# RM Housing Opportunity Areas

# Area 1: 600 Park Avenue

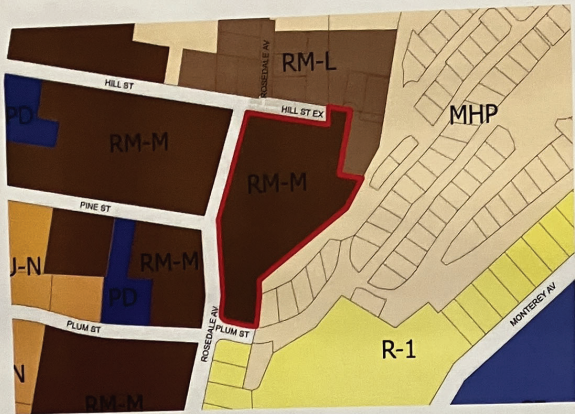
400 - Not suitable → R20 only  
 1) park area surrounded by R-1  
 2) Most of the parking on site is occupied  
 3) Not walking distance to amenities  
 a) store, FC, bus stop  
 b) transit station  
 4) R20 only takes over 200 ft  
 5) Bus service stopped due to local  
 redneckism

Good  
 Absolutely since very low density, the  
 core area could put some little  
 parking in Capital  
 Do not remove existing parking

One of the Only True  
 Low Income Housing Units  
 Leave it Alone & don't  
 Price folks out

ABSOLUTELY. One of the only  
 remaining large parcels that can  
 accommodate well-designed and  
 truly high-density multifamily  
 residential development (at least 30 du/acre)  
 Please create some renderings to  
 show people how it can be done in a  
 way that won't scare them.

Area #1  
 within Residential  
 neighborhood on  
 both borders  
 not enough parking  
 now.

Area #1  
 80 units of Low  
 income housing.  
 All Low income.  
 Currently !!!

# Area 3: Capitola Ave & Hill

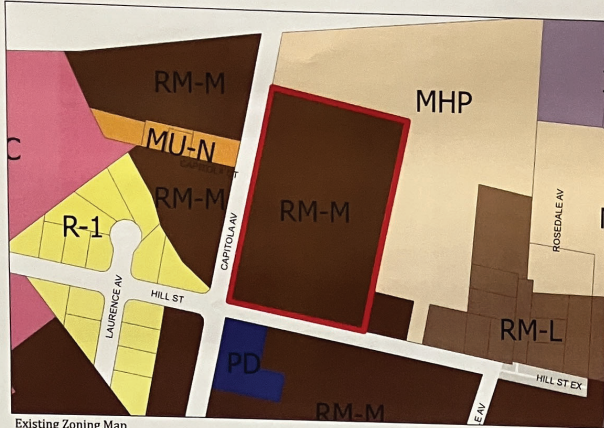
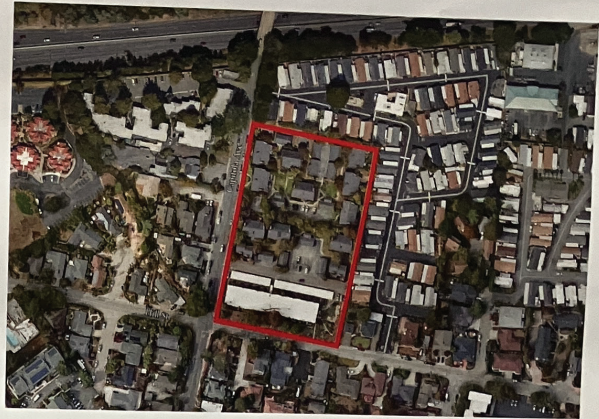
There is NO EXTRA PARKING on Capitola Rd on Hill St. NONE!!!  
 We already live with the freeway on one side of it. There are more cars please don't. Build high so we lose our privacy as well.

Area 3  
 I don't see how more units could be added without demolishing existing units. Do not remove parking.

Parking is already inadequate for neighbors on Hill St on Capitola Ave.  
 Tall building would not allow sun to enter onto yards that already get little light.

If you change 15 du/ac to 30 x 4.3 acres = 129 units  
 existing = 72  
 = 57 more units?!  
 How do you maintain any greenspace, play area, setbacks?

**CONCERNS:**  
 Height  
 Set back  
 Density  
 Parking

- Yes, with qualifications
1. Adequate set backs from adjacent property to make sure multi don't block light
  2. Adequate parking
  3. Better public transportation for higher density
  4. Will only support small increase in density ~25%

AGAINST AREA 3  
 THOSE BLDGS PUSHED AGAINST USE OF NEIGHBORS  
 POLICE DISTRICTS PERMITS & IMPROVE PERMITS TO SOLAR ACCESS TO PEOPLE  
 IN MY DISTRICTS. PEOPLE

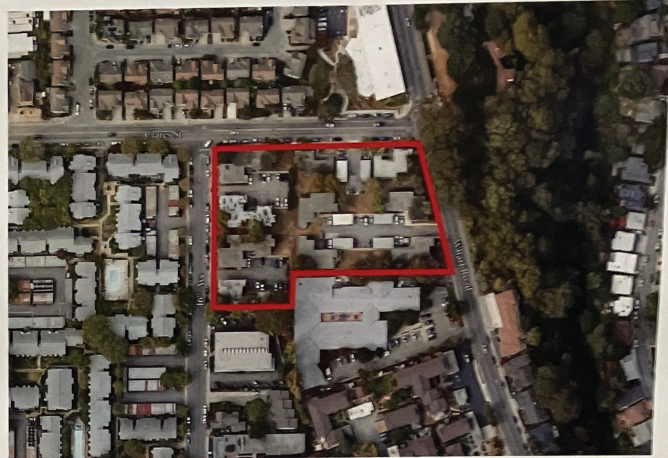
Yes. Redevelopment may not happen, but our ridiculously low high-density density limit of 20 du/ac should be raised to at least 30 du/ac.

# Area 5: Capitola Cove

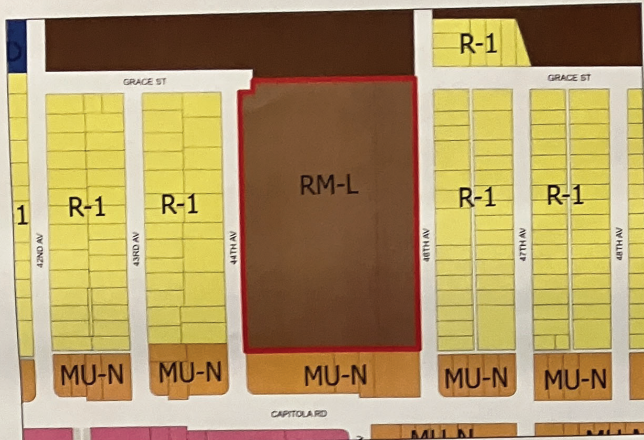
Area 5  
Potentially if some old buildings  
Do not remove existing parking  
SF to south side of lots - East side  
Very little open space, very little  
park area in Capitola

Area 5  
Not suitable due to already  
identified potential for 2500  
units in the mall/office center,  
as well as existing multifamily  
throughout this neighborhood/region  
of the city.

Yes. If nothing else, please at least  
make the density accommodate the  
built density to bring it into compliance  
with the zoning. Setbacks would be  
preferable.

## Potential RM Zone Development Standards

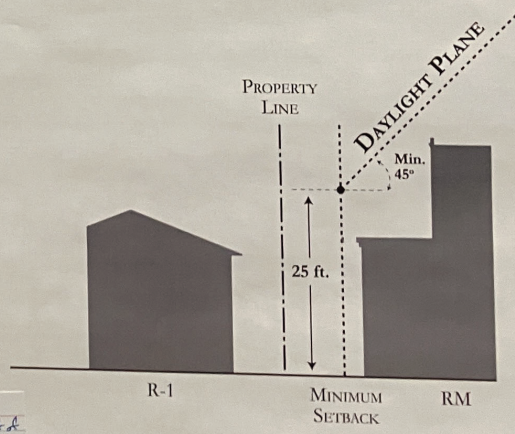
Capitol already has built housing at >30 du/acre. This is too low.

Builders can do what they want. Where do we propose "potential new"?

Make density higher (you had 40 du/acre last Aug)

Why didn't we talk about this standard? This is the main thrust of Section 16.20 du/acre is clearly a constraint on residential/multifamily development in the City. It needs to be raised to at least 30 du/acre for all high density multifamily residential zoned (R-HB) parcels!  
HCD will not accept anything less!
